DATE: February 11, 2019
TO: Blue Bird Owners
Subject: Recall R18ZE, Intermittent Air Gauge Operation (Noncompliance)

IMPORTANT SAFETY RECALL NOTICE

NHTSA Recall Number: 18V-263 School Bus
NHTSTA Recall Number: 18V-264 Non-School Bus

SUBJECT: Recall R18ZE, Intermittent Air Gauge Operation (Noncompliance)

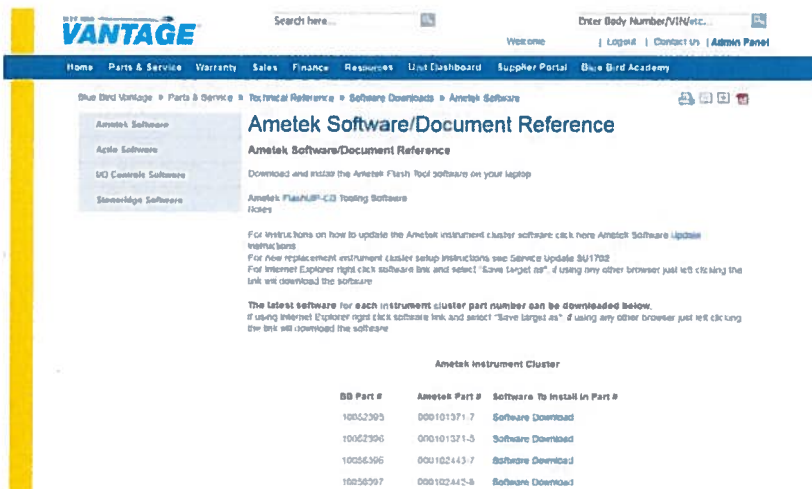
When turning the key to the ignition "ON" position, the two gauges on the instrument cluster that display primary and secondary system air pressure intermittently display "0 psi" instead of the correct air pressure in the tanks.

Affected buses will require instrumentation software be updated to the latest version. Complete the corrective action software update procedure below.
